Subject: **Additional Information Request**
Saxon Falls Hydroelectric Project (FERC Project No. 2610)
Superior Falls Hydroelectric Project (FERC Project No. 2587)

ADDITIONAL INFORMATION

Figure 1 Gogebic County Snowmobile Trail Map

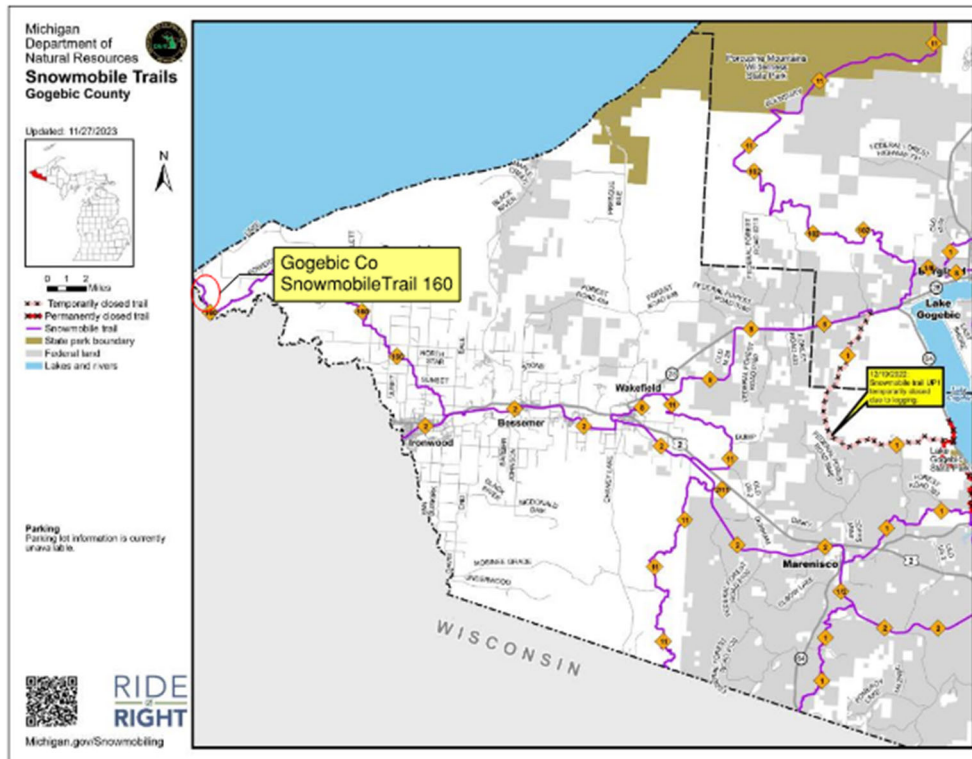
A description of: (1) recreation use policies and any agreements for public use of the current project lands proposed to be removed from the project boundaries (e.g., snowmobile trails, hunting, camping, hiking); (2) any known recreational uses on lands proposed to be removed from the project boundaries such as hiking or camping as well as any recreation management practices; (3) any maps showing the network of road/trails available for public use and access; and (4) a description of Northern States' maintenance activities and frequency of maintenance that occurs

There are existing agreements allowing the use and maintenance of Gogebic County (Michigan) snowmobile trail 160 on NSPW-owned lands within the current Project boundary. The agreements include a lease to the Gogebic Range Trail Authority, a license agreement with a private landowner, and an outdoor recreation trail use agreement with the Sno-Drifters Club. These agreements are included in **Appendix AIR-2**. No changes to the trail or agreements authorizing its use and maintenance are anticipated in the reasonably foreseeable future as a result of the removal of the underlying lands from the Project boundary. The snowmobile trail is maintained by the Gogebic Range Trail Authority and the Sno-Drifters Club and is shown in **Figure 1**.

Figure 7- Electronic Map Showing Heritage Chapter “Roadwalk” Segment of NCT

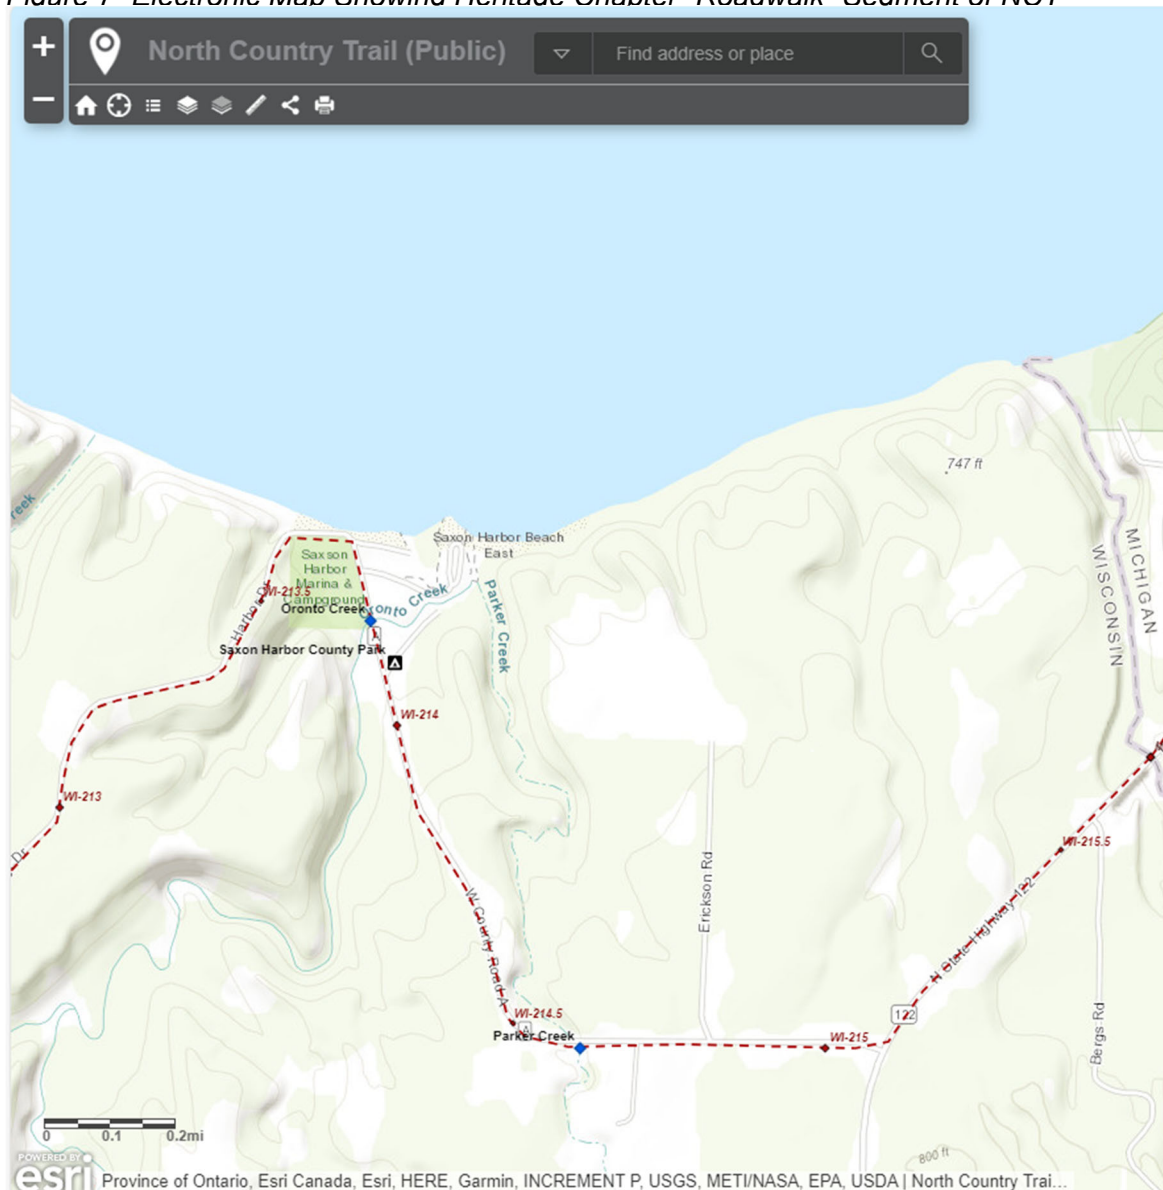
Table 8.1.2-2 lists the North Country National Scenic Trail as being within the Superior Falls Project boundary, but Figure 8.3.2.2-1 shows the North Country Scenic Trail as being outside the proposed project boundary. Please clarify whether any sections of the trail are in the current or proposed project boundary. In addition, please state who is responsible for maintenance of trail.

The North Country Trail (NCT) crosses Superior Falls Flowage along Wisconsin Highway 122/Gogebic County 505 (Lake Road) but is not included in the project boundary. This section of the NCT is managed by the Heritage Chapter of the NCT in Wisconsin and the Ni-Miikanaake (NMK) Chapter of the NCT in Michigan. The Wisconsin portion of the trail is a “roadwalk” from US Highway 2 to the Michigan border. **Figure 7** shows this portion of the trail extending from Saxon Park to the Michigan border. Dotted lines indicate the trail is a “roadwalk.” A description of the Heritage Chapter Segment of the NCT is included in **Appendix AIR-7** and is found at the following web link:

Sections of the NCT designated as a “roadwalk” are literally a walk along an existing road and lack an actual physical trail. These “roadwalk” sections connect completed off road sections of the NCT. Hikers using these connector routes simply walk along the road until they reach the next completed trail segment. NSPW traveled the portion of the trail from the Michigan border to Saxon Harbor Park. No signs identifying the NCT were located anywhere along this section.
